Memo: M015-A

Ancoats Gardens, Rochdale Road, Manchester

Proposed acoustic testing schedule

Level 13

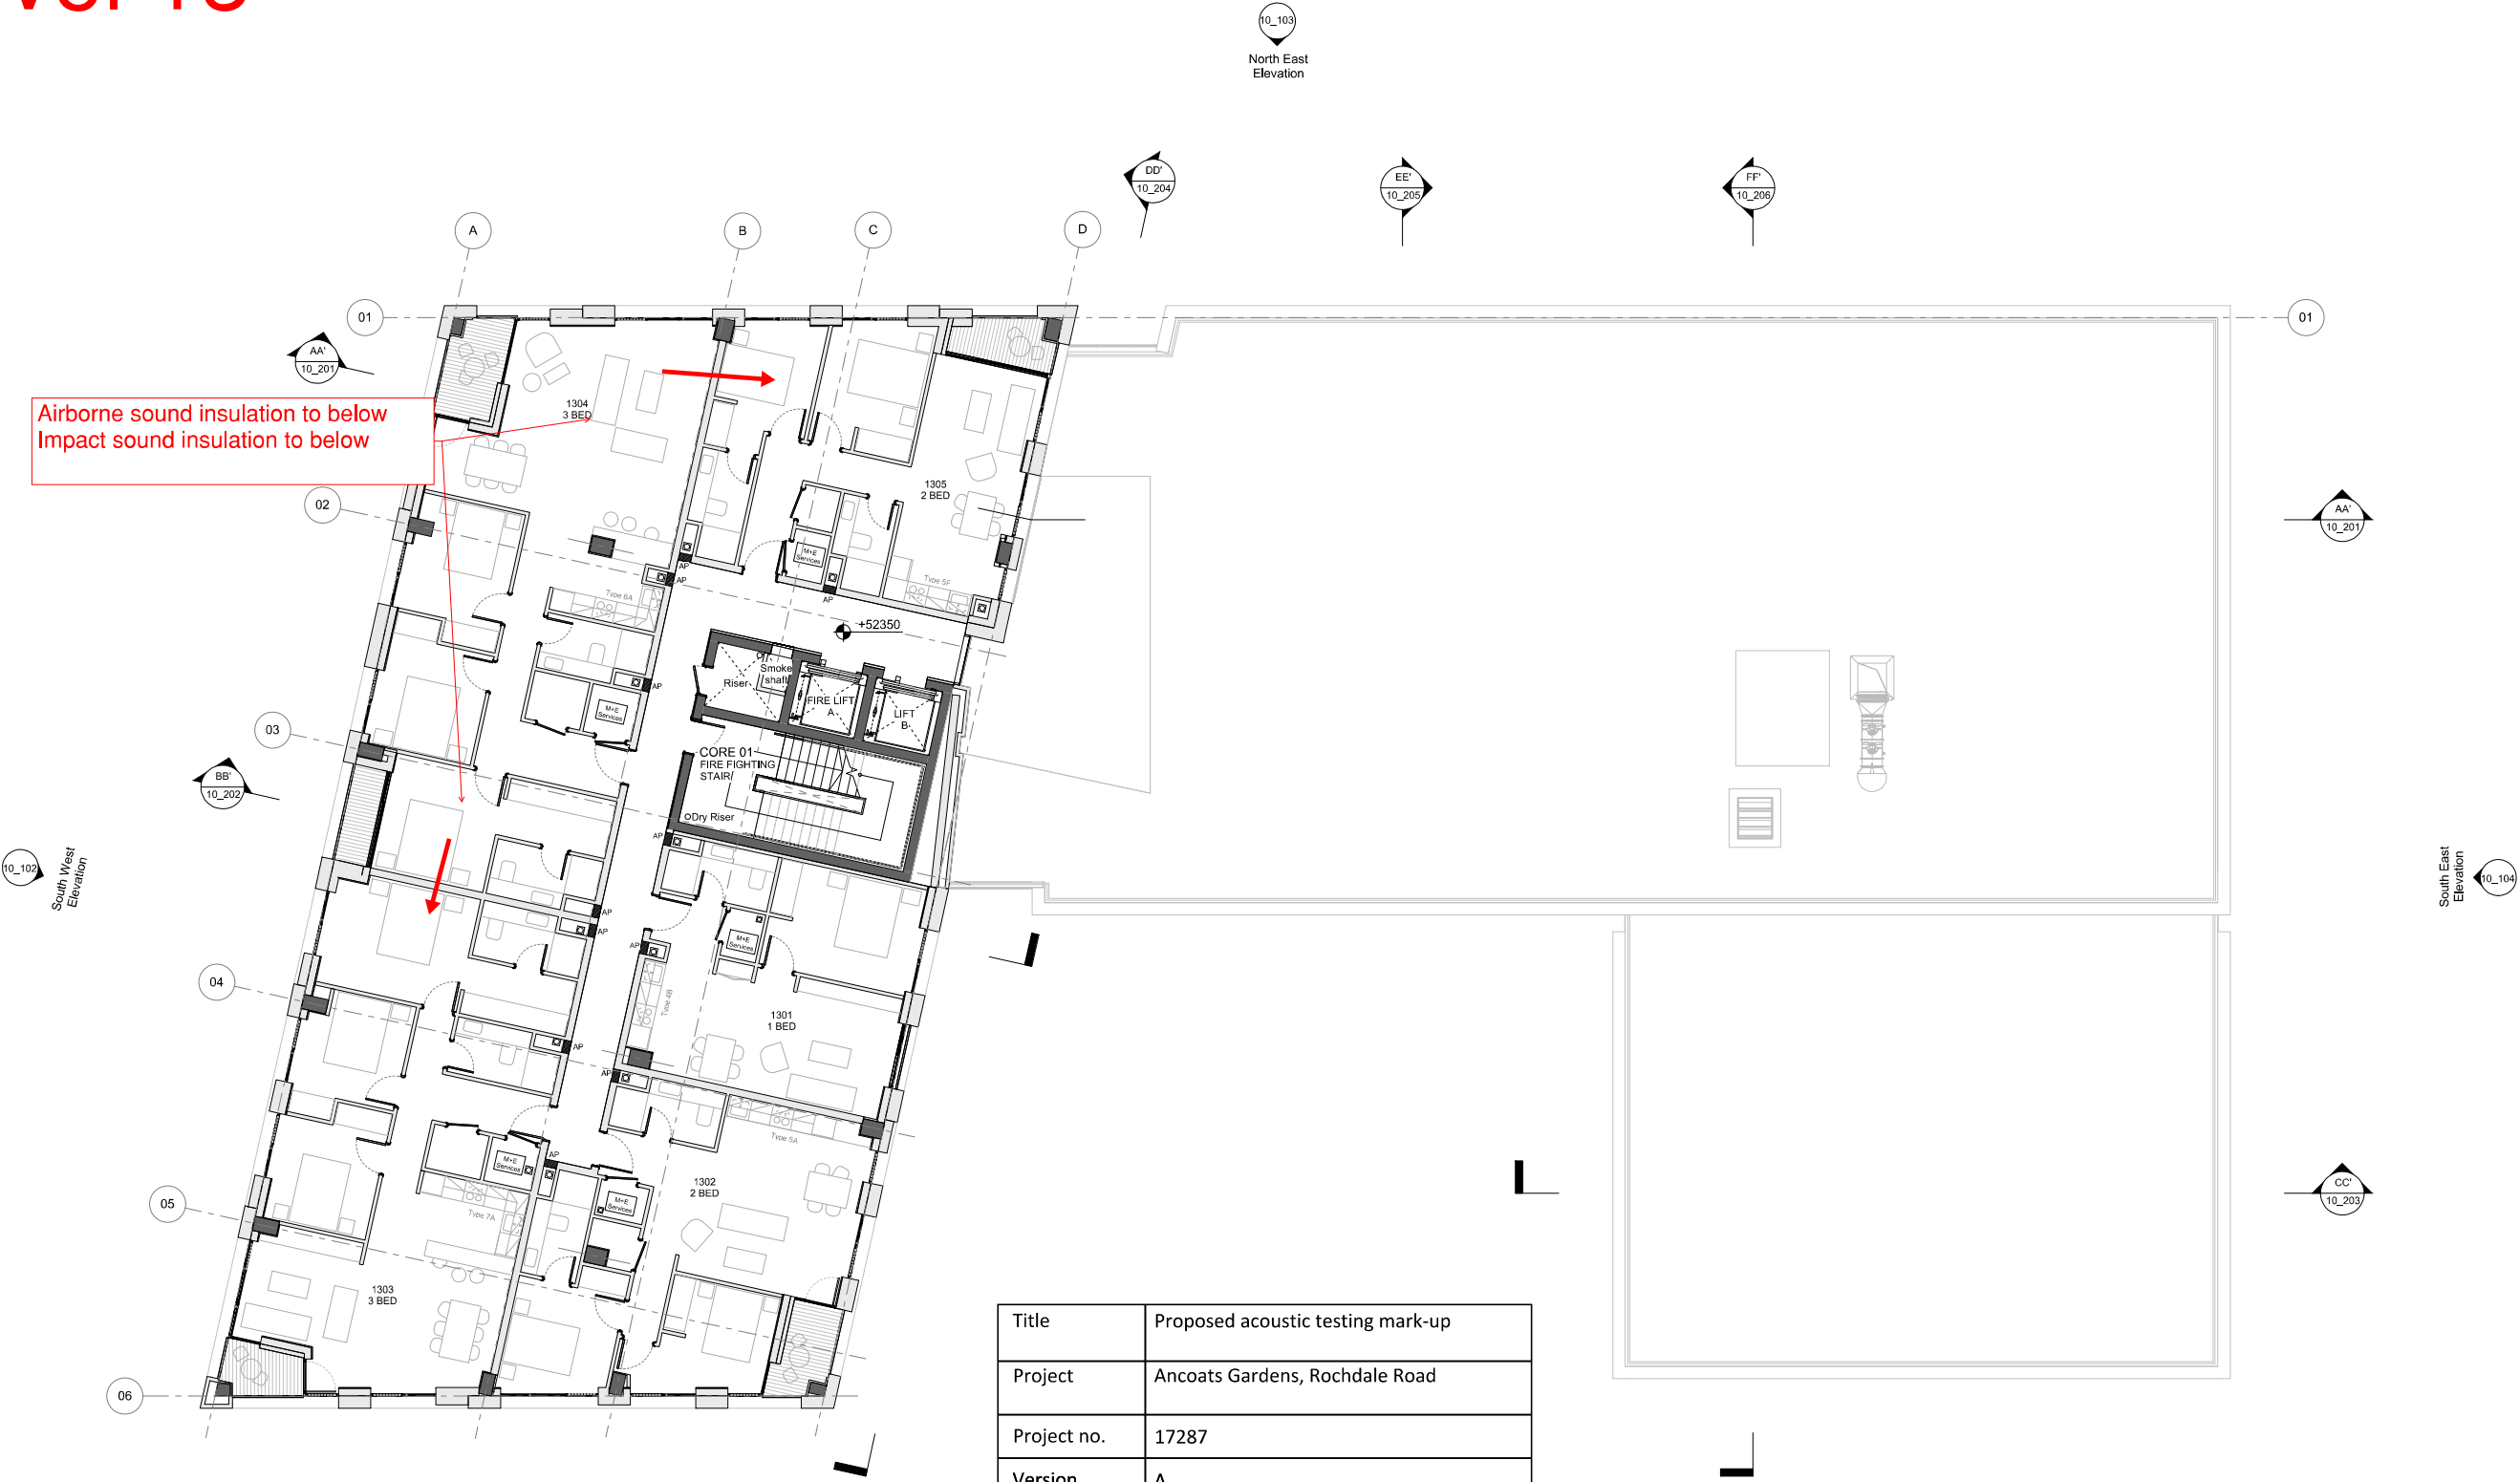
Airborne sound insulation to below
Impact sound insulation to below
